N1076B-04

Information Only Service Note

N1076B 64 GBd Electrical Clock Recovery

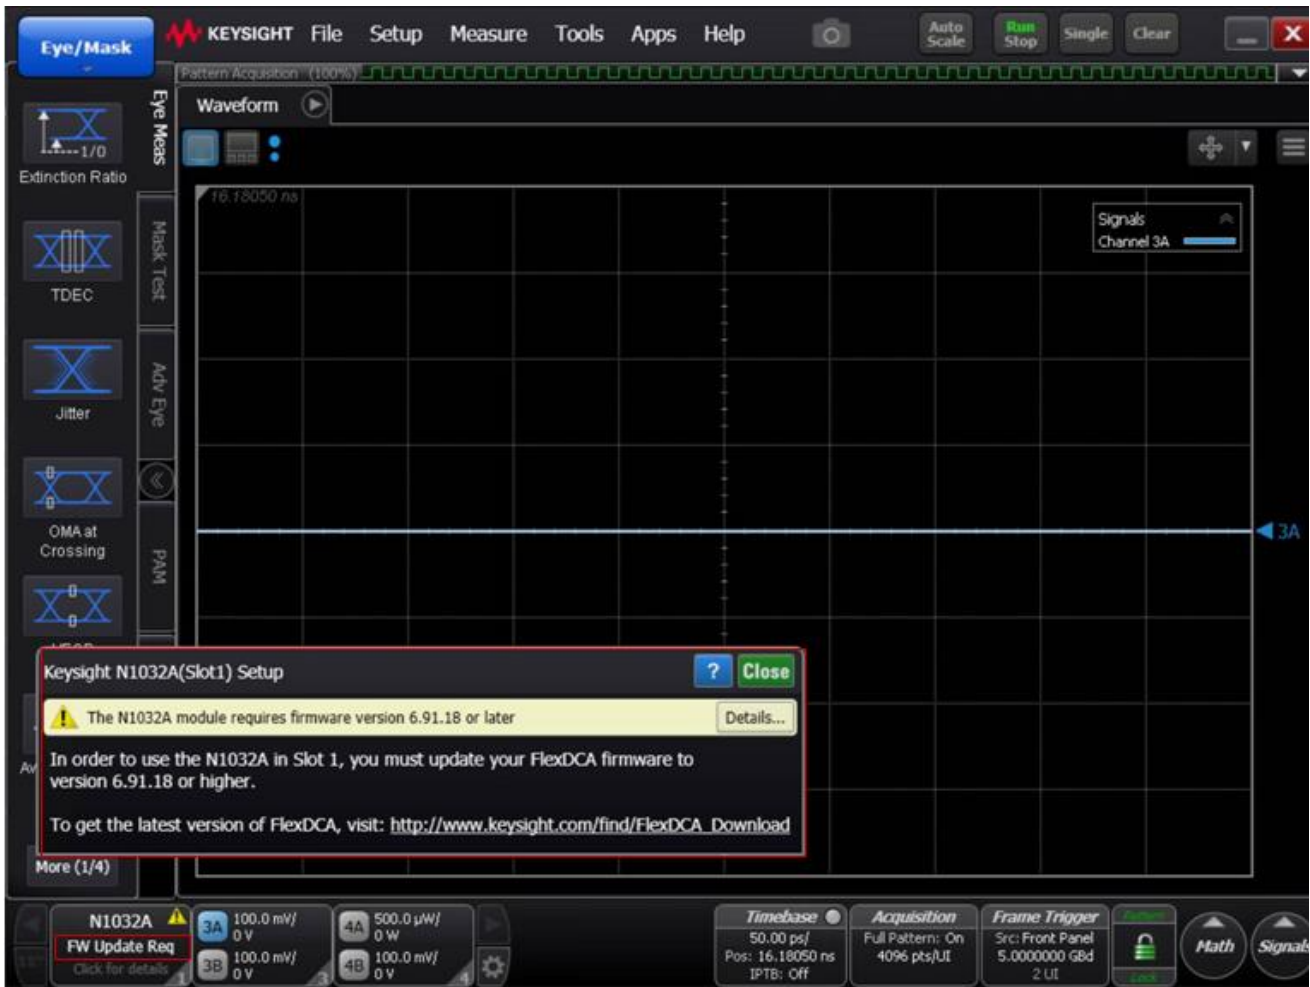
With the instrument connected to FlexDCA, if a message like the one below is displayed, FlexDCA must be updated to the indicated version (or later):

To update FlexDCA software, download from www.keysight.com/find/flexdca_download and install. While only the indicated version is required, updating to the latest version is recommended.
